Network Video Recorder
Version: V4.30.000 build 200508
Release Note

Firmware Basic Information	Firmware Version:	V4.30.000build200508
	SDK Version:	V6.1.4.20_build20200320
	Play Library:	V7.3.7.39
	Web component:	V4.0.1 build200507
	OpenSDK Version:	V2.5.0

Reason of Upgrade

1. 【Support adding motion detection 2.0 IPC】

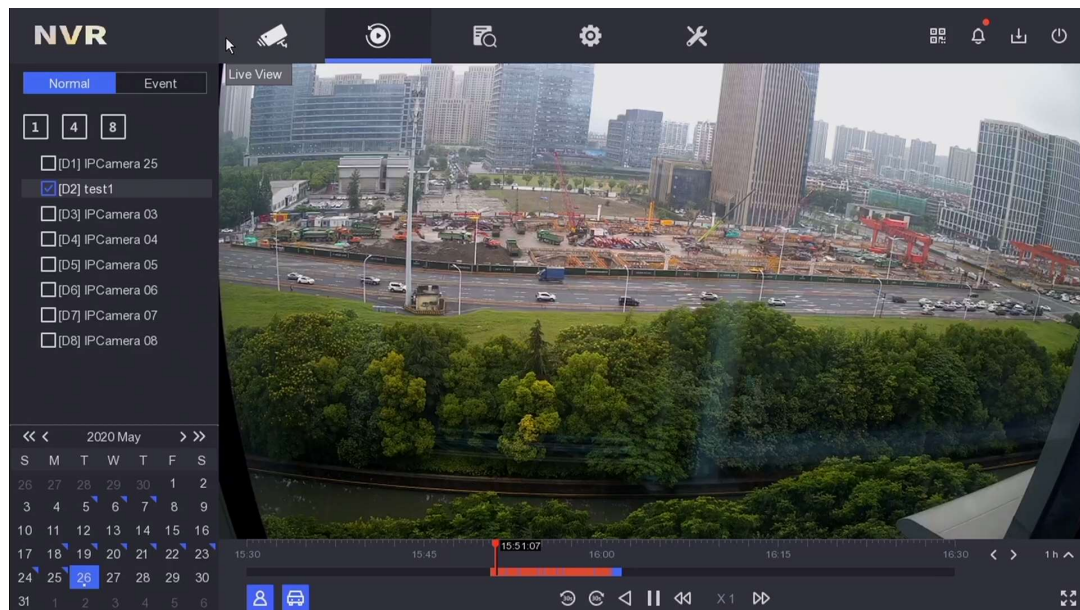
1) Support IPC with motion detection 2.0 function, the specific model of IPC is DS-2CD20 (23 / 2T / 26) 2 (4/8) 6G2-I / SL, such as: DS-2CD2026G2-I / SL. The firmware version of IPC is required to be V5.5.130 and later.

2) Support the local GUI, IE and 4200 to configure the target filtering of human body and vehicle.

The smart playback interface for local playback and the remote ordinary playback interface add the option of human body-vehicle filtering. After checking, the human body-vehicle video information will be marked in red on the progress bar.

2. 【Support access in ISUP 5.0 protocol】

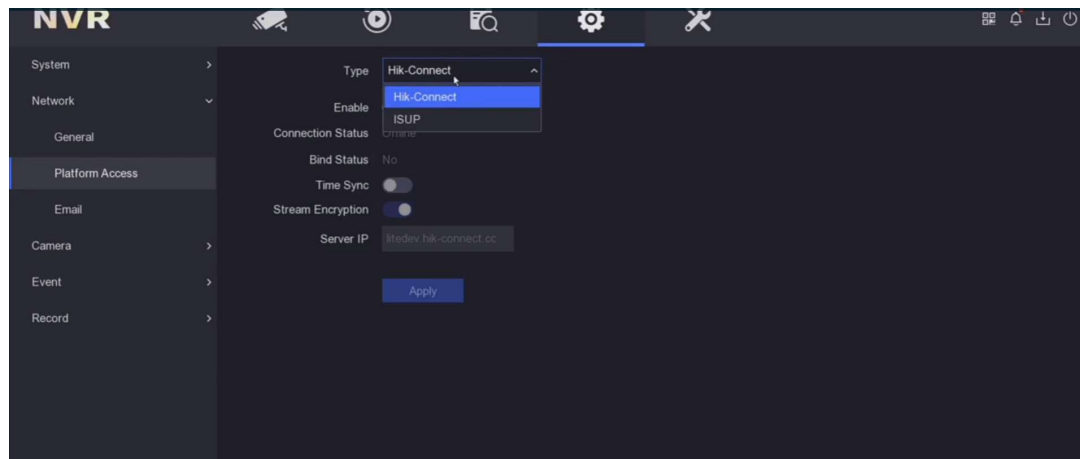
- 1) Overseas product support adding ISUP 5.0.
- 2) Support the configuration of preview, playback, two-way audio and FTP upgrade.

3. 【Support Hik-Connect to enable One-Key Do Not Disturb function】

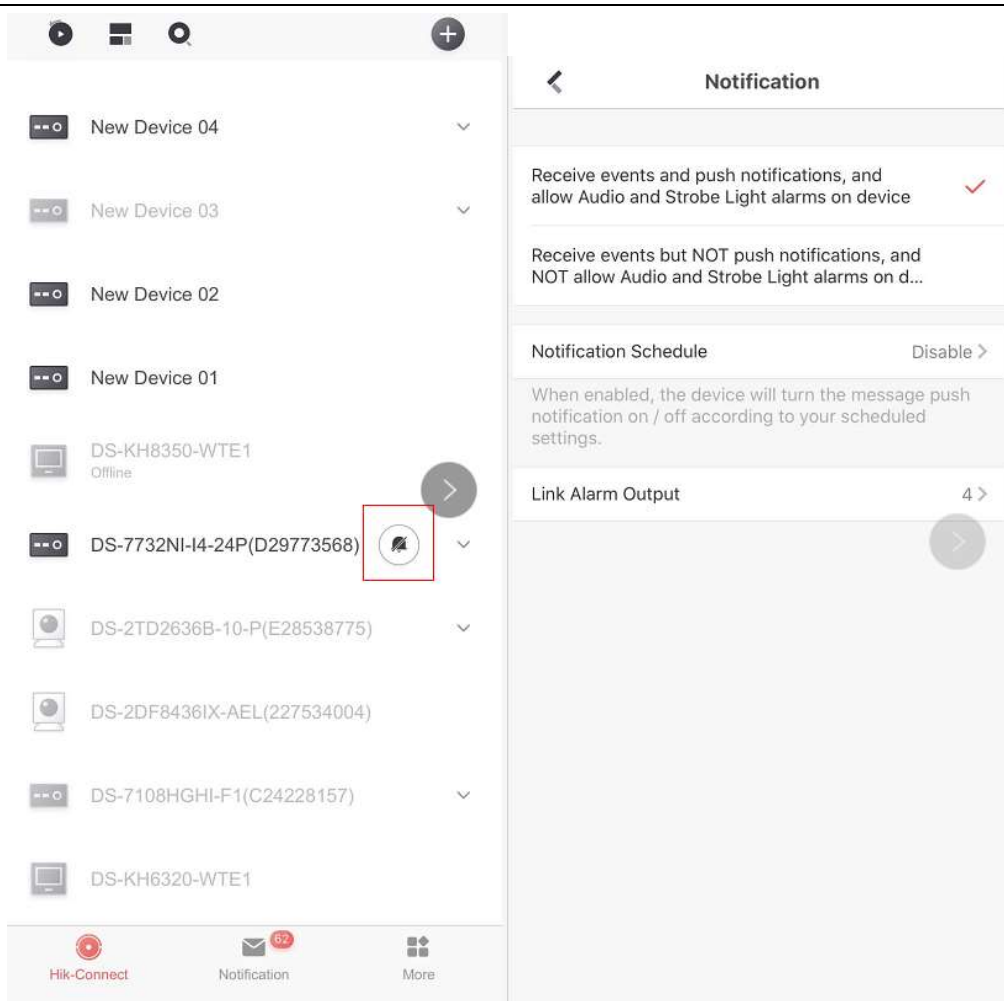
- 1) After Hik-Connect enables the One-Key Do Not Disturb function, all event linkage action will be cancelled.

4. 【Support Hik-Connect / GuardingVision to scan NVR QR code to recover password】

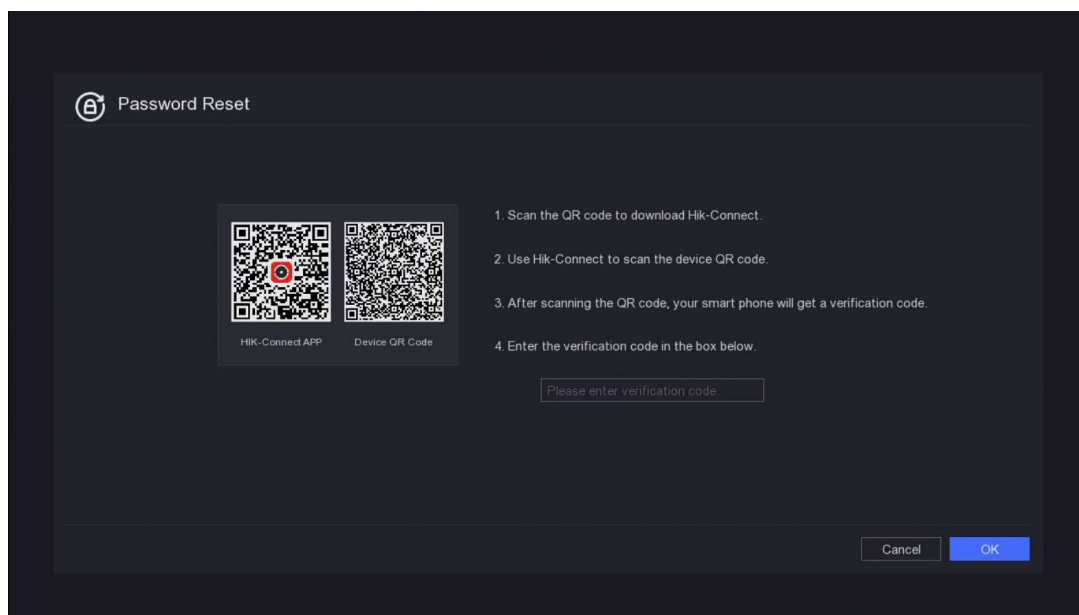
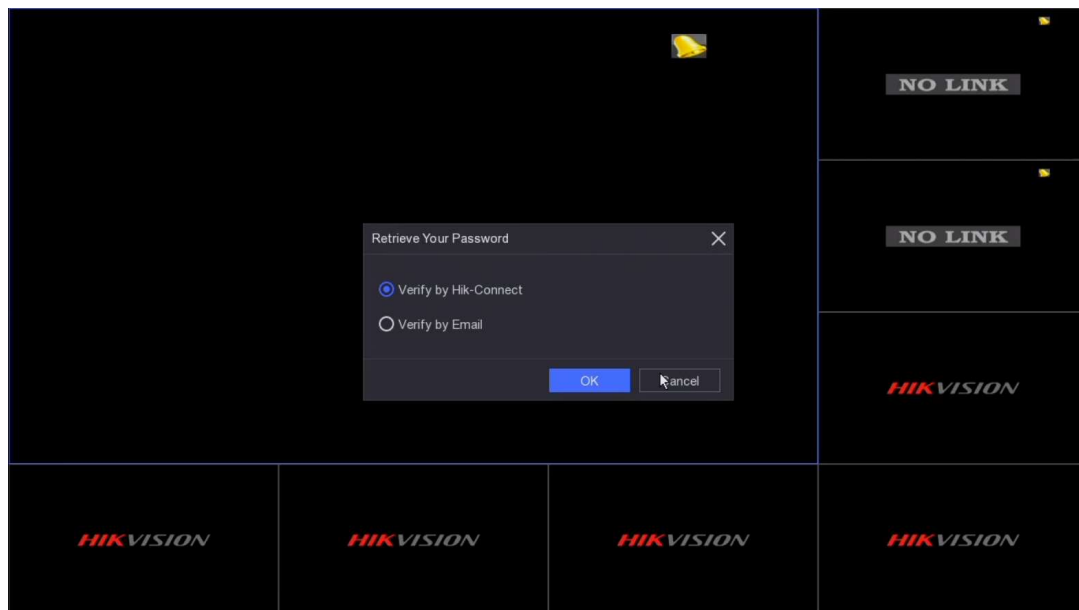
1) Support local HC / GV scanning QR code and mailbox to recover password, Local GUI delete the recovery way of GUID and security issues; WEB still retain GUID, security issues and mailbox to recover password.

- 2) Only the NVR that has been bound to the HC / GV will display the option to scan the code to recover the password.
- 3) Only the NVR-bound HC / GV client account can successfully recover the password.
- 4) Require HC/ GV v4.3.0 and later.

5. 【Support GUI local online upgrade by Hik-Connect】

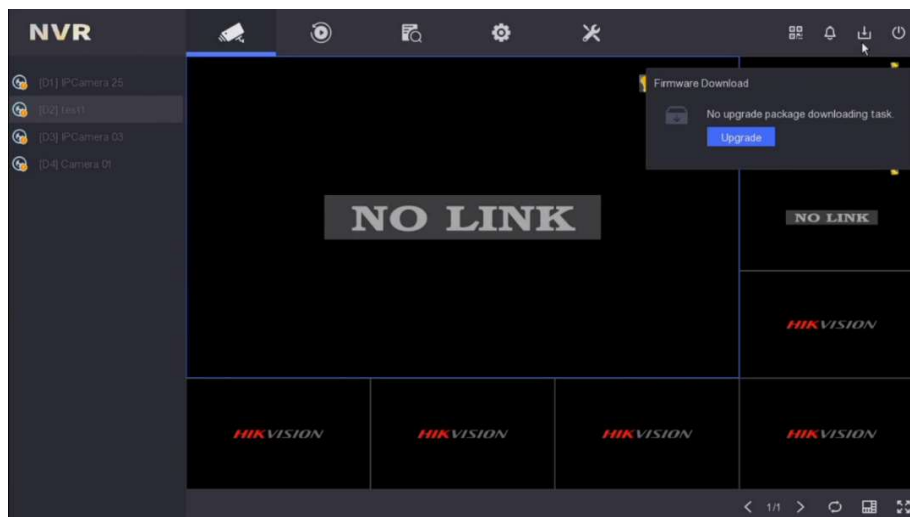
1) Support IE, GUI local Hik-Connect online upgrade.

2) Support HC remote upgrade

3) Remote upgrade will be pushed to the main menu interface, there will be a red dot prompt in the upper-right corner of the main interface

7. 【Support two-way audio function with Hik-Connect】

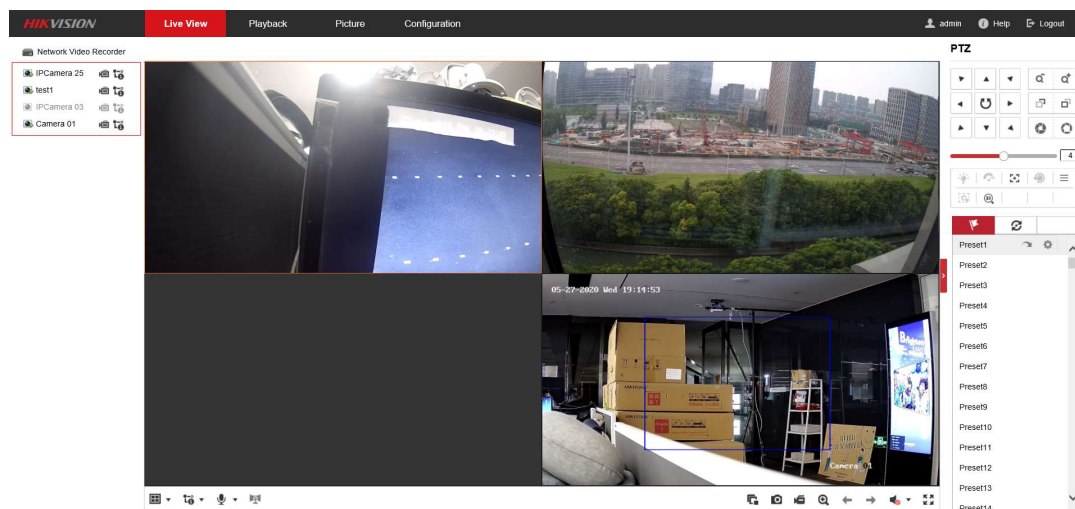
Hik-Connct client can talk directly with certain channel IPC of NVR.

10. 【Optimization of PoE exception information display】

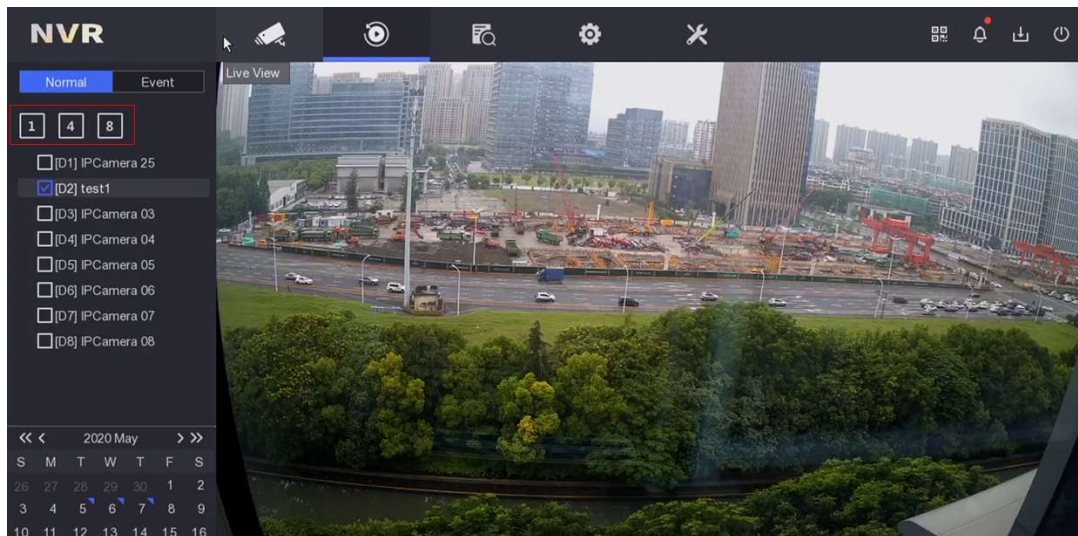
1) When switch connect to NVR PoE port, no short-circuit or error information will display.

2) Cameras that link with Switch which connect to NVR PoE port, could also connect to NVR through this switch.
